DEVELOPMENT REVIEW BOARD REPORT

112-DR-2005
Atrium 7700

Request approval of a site plan and elevations for remodel and conversion of an existing apartment complex to a condominium complex.

Stipulations for Case: Atrium 7700 Case 112-DR-2005

LANDSCAPE PLAN

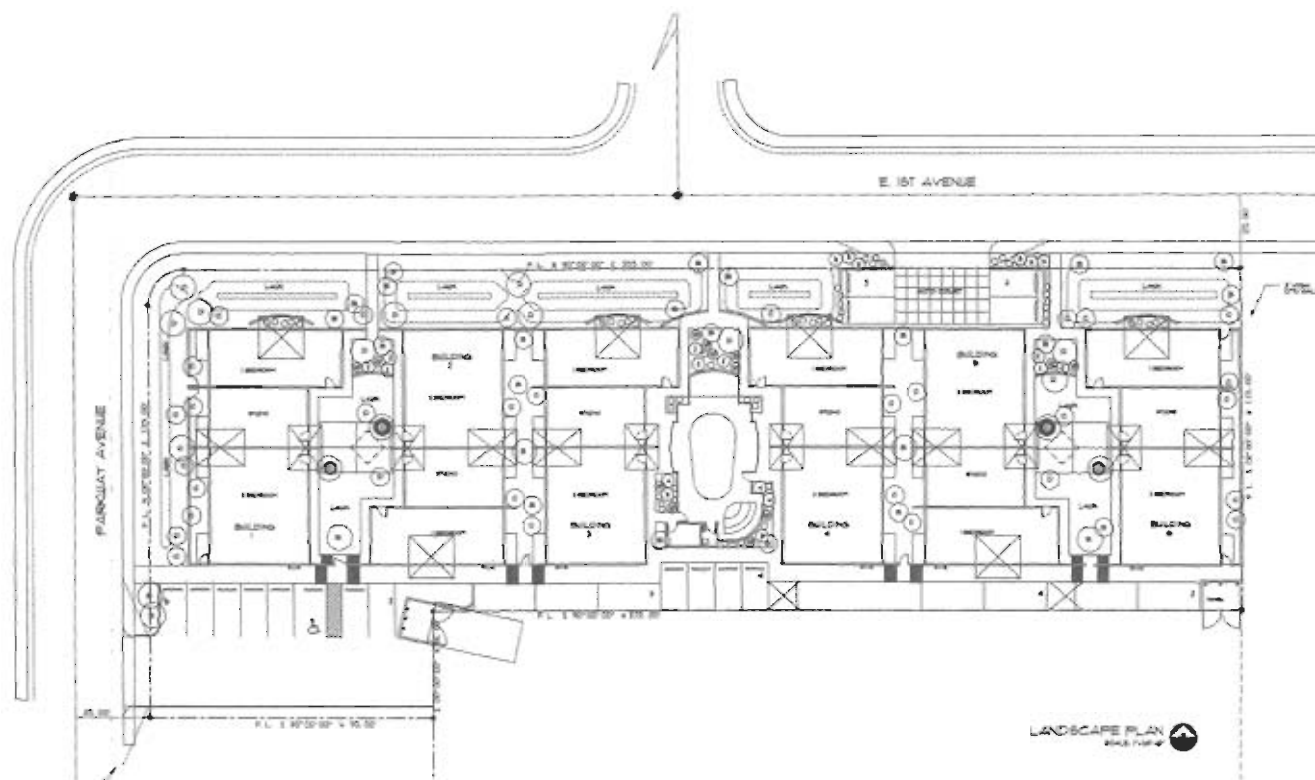
10. Upon removal of the salvageable native plants the salvage contractor shall submit completed Native Plant Tracking Form as well as a list identifying the tag numbers of the plants surviving salvage operations to the City's Inspection Services Unit within 3 months from the beginning of salvage operations and/or prior to the issuance of the Certificate of Occupancy.

- A. *Fifty percent (50%) of the trees provided for this site shall be mature, as defined in Article III of the Scottsdale Zoning Ordinance.*
- B. *Other than the proposed turf, landscaping for this site shall be selected solely from the Arizona Department of Water Resources Low Water Use / Drought Tolerant Plant List (ADWR).*
- C. *The maximum area for water intensive landscaping shall not exceed the allowable area in accordance with Section 49-246 of the City Code.*

ATTACHMENT #8

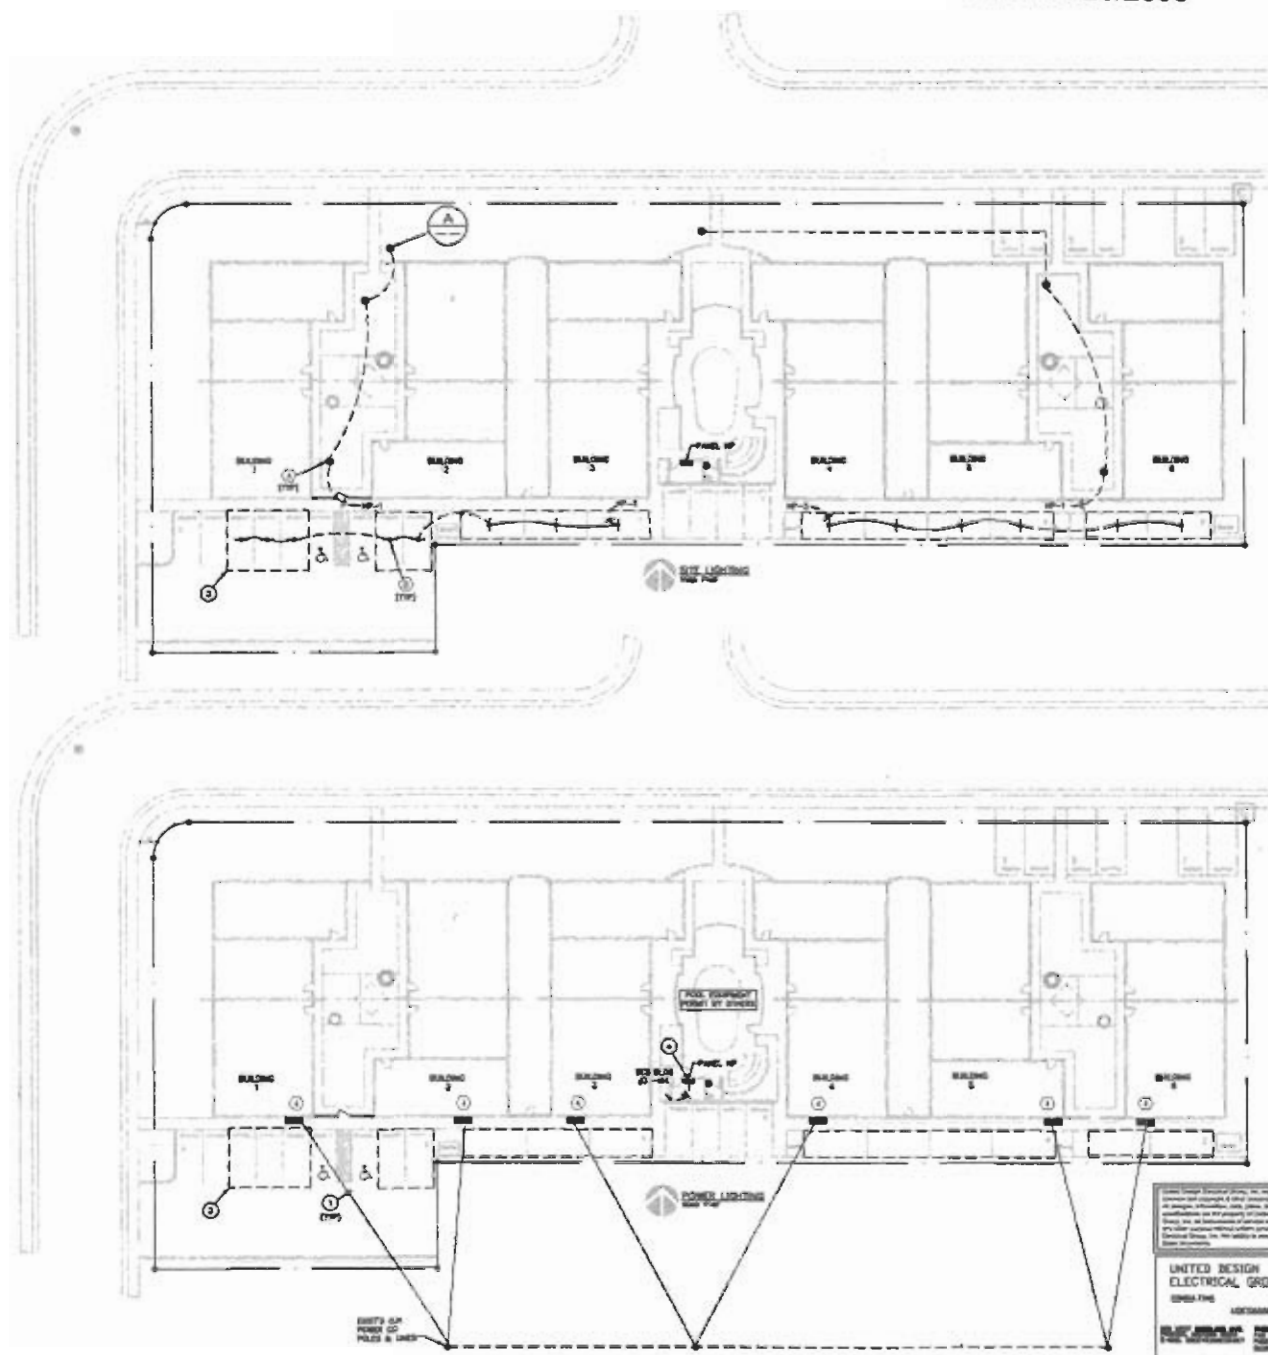
11. *No site lighting approved as part of this submittal. Any request for future site lighting shall be submitted for separate approval by the Planning staff, and may be subject to additional approval by the Development Review Board.*
